**Meghan Pump Station (RFCSP)
Solicitation Number: CO-00645
Job No.: 19-1006**

**ADDENDUM 7
November 2, 2023**

2.2 AIR CONDITIONER

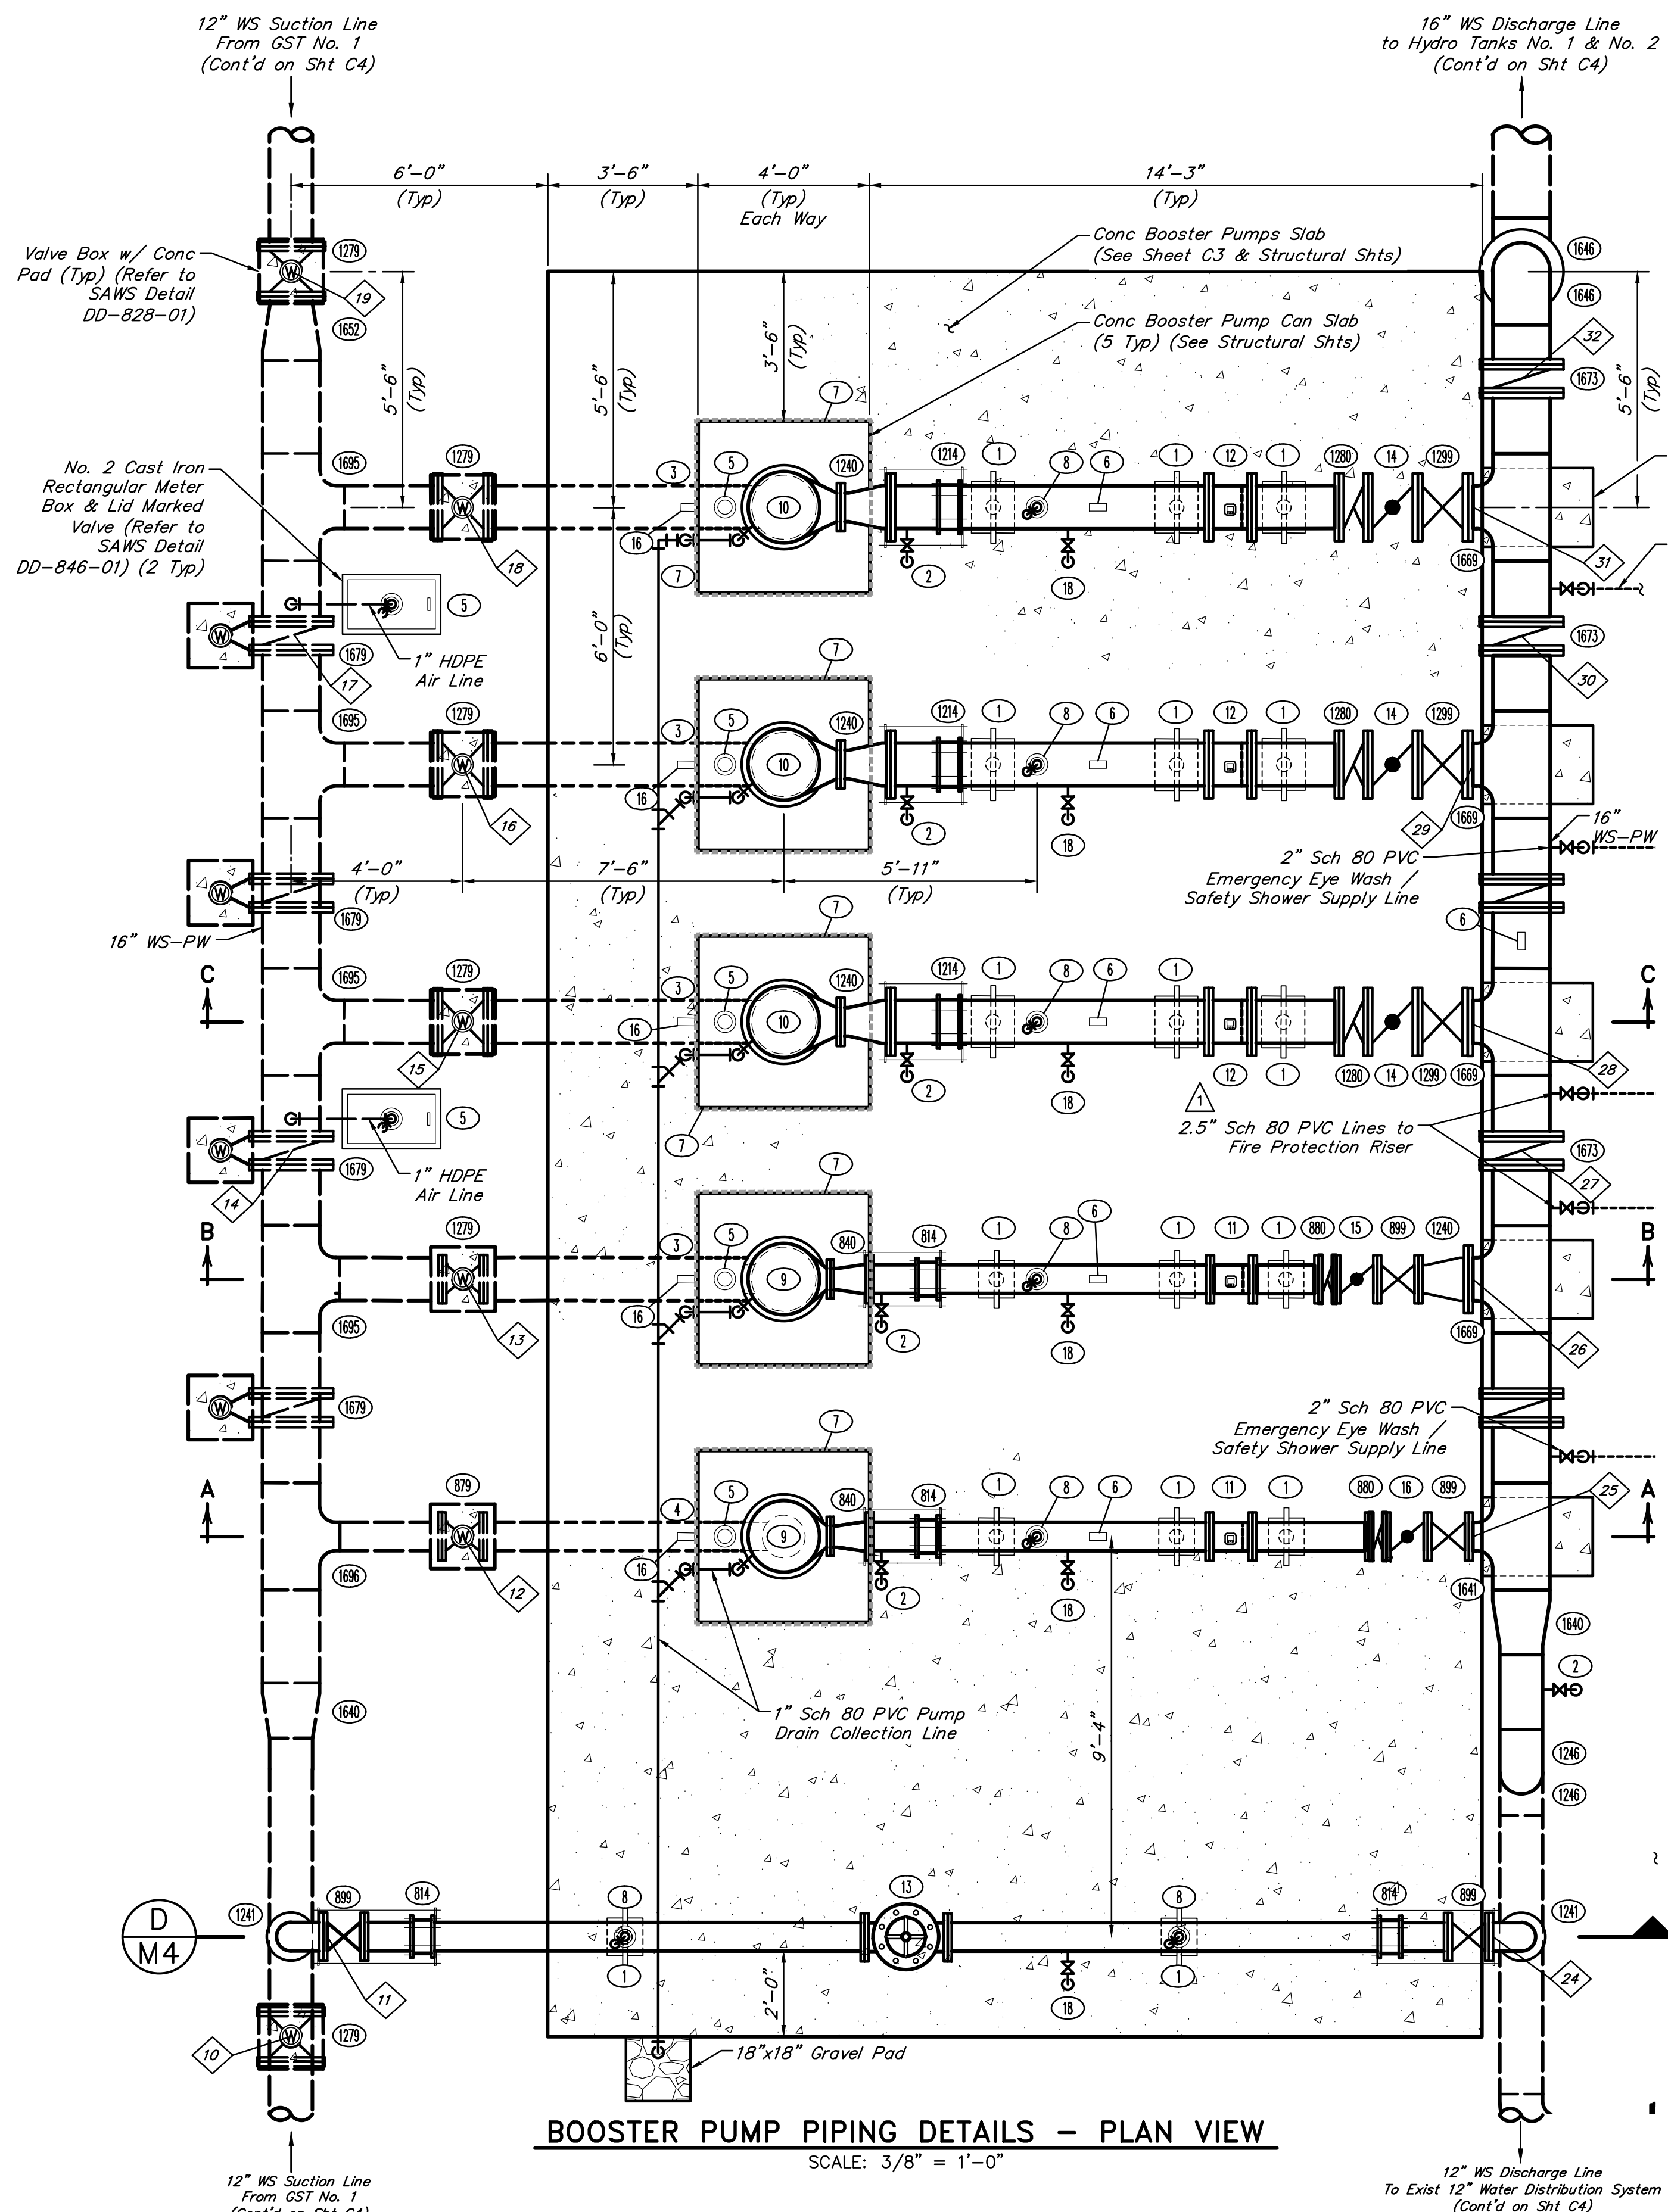
- 2. Question:** Spec Sec 15201 Item 2.2 Air Conditioner calls to provide and install two (2) Bard Model No. W24BB-XC05X5X electrical heat air conditioners. However, the specified model is not valid. I have attached the current Bard nomenclature sheet that will hopefully help confirm the model number. Please advise if the model number should be W24AY-C05XXXX5J.

Response: See changes to plans and specifications, this addendum. Confirmed. The correct model number is W24AY-C05XXXX5J. The indicated revisions to the plans and spec have been made.

- a. Provide and install two (2) Bard Model No. W24AY-C05XXXX5J electric heat air conditioner. Air conditioners and heaters are to have automatic temperature control. Air conditioner output: 24,400 BTU. Heater output: 15,700.
